Accredited Standards Committee
X3, Information Processing Systems

Doc: X3T10.1/96a142r5
Date: September 4, 1996
Project: X3T10.1/1146D
Ref Doc.: SSA-PH2 rev 2
Reply to: John Scheible

Subject: SSA-PH2 changes proposal

Figure 6 - Test environment for drivers

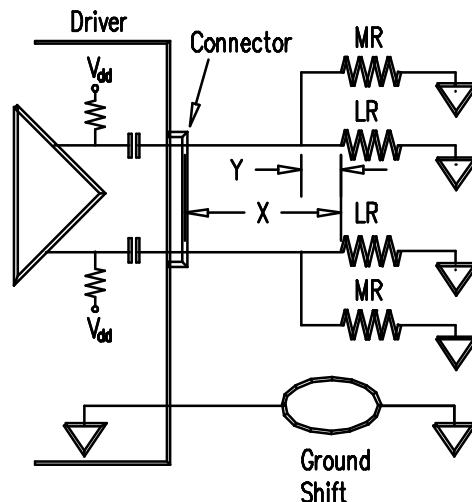
Dave Instone pointed out that rev 1 changes that were backed out should not have backed out the change from 2 pF to 1,5 pF which is restored in this proposal. Dave also pointed out the at line difference of 5 mm applied from the connector to the measurement point, and not connector to load resistor.

- a) Modify Figure 6 as shown below.
- b) Change the first paragraph of 7.1.3.1 to...

Line drivers shall be tested using the test circuit shown in Figure 6. Line Driver measurements shall be made at the port connector. The distance between the port connector and the load resistance LR (labeled X in Figure 6) shall not exceed 5 cm. The distance between the measurement point (at the LR and MR junction) and the load resistance LR (labeled Z in Figure 6) shall not exceed 5 mm. The difference between the connector to measurement point distance (labeled Y in Figure 6) of the LineOut+ and LineOut- lines of the driver shall not exceed 5 mm. The resistance of the combined load resistance LR and measurement resistance MR shall be $75 \Omega \pm 2\%$. The connecting media shall meet the requirements in 7.5 for this test. The total additional capacitive load from the scope probing scheme between Line+ and ground and between Line- and ground at the port connector shall be a maximum of 1,5 pF. This capacitance includes the sensing probes and equipment added to enable probing. Additional discrete capacitors between the scope probes and the port connector ground may be needed. The load shall conform to the characteristic impedance requirements in 7.3 at its connector.

Figure 9a - Line Driver termination schematic

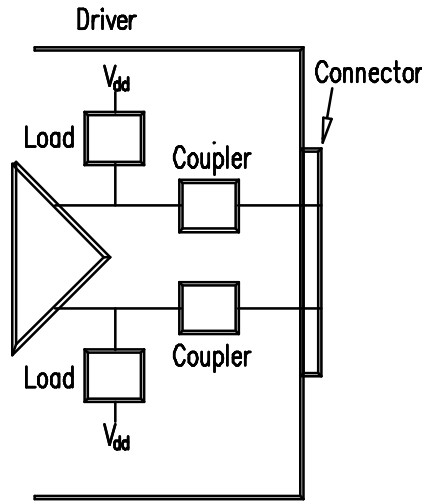
- a) Replace 7.1.6 with the subclauses shown below
- b) Modify "7.3 Line Segment termination" as shown below.
- c) Add two new rows to Table 6 labeled "Lineout+ leakage current to ground" with a maximum of "10 μ A d.c.", and "Lineout- leakage current to ground" with a maximum of "10 μ A d.c.".

Figure 9a illustrates the schematic of the Line Driver.

The Line driver termination is defined in terms of TDR impedance in the same way as Line Segment termination except it is measured at the Port connector Linout pins (see 7.3). Table xx specifies the Line Driver termination requirements.

Each Line Driver load is a resistor with a d.c. impedance of $75 \Omega \pm 1\%$ connected between LineOut and V_{dd} .

The Line Driver coupling element is an element that is capacitive at 20 MHz and has a maximum impedance of 10Ω over a frequency range of 20 MHz to 500 MHz. Any self resonant frequency shall occur above 75 MHz. For example, this may be achieved with a $1 \text{ nF} \pm 20\%$ capacitor which meets the Line Driver coupling element requirements.

Figure 1 - Port connection segment test load

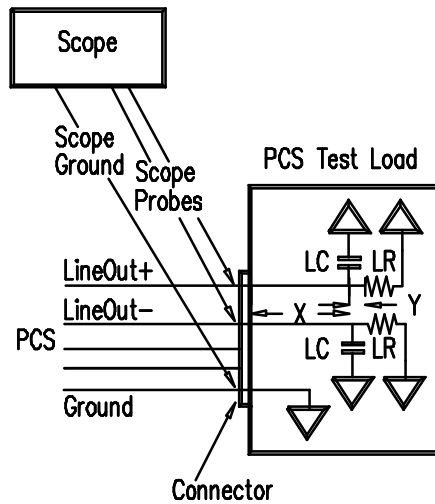
Dave Instone’s proposal (96a158r0) rewrote section 7.5.1. SSA-PH is not written very definitively (SSA-TL and SSA-S2P/S3P are a little better). Definitive writing is an art, I have modified Dave’s proposal to meet the definitive writing style and ask for your input, especially regarding changing “is” to “shall”. I also changed the meaning of the last sentence as per my reflector note. The modified section is shown below. Revision marks indicate changes from Dave’s proposal.

7.3 at its connector. The values of LR, LC, X and Y in Figure 1 shall be $75 \Omega \pm 1\%$, 3 pF , $5 \text{ cm} \pm 5 \text{ mm}$, and $5 \text{ mm} \pm 1 \text{ mm}$ respectively. The scope probe shall have capacitance of $3 \text{ pF} \pm 20\%$.
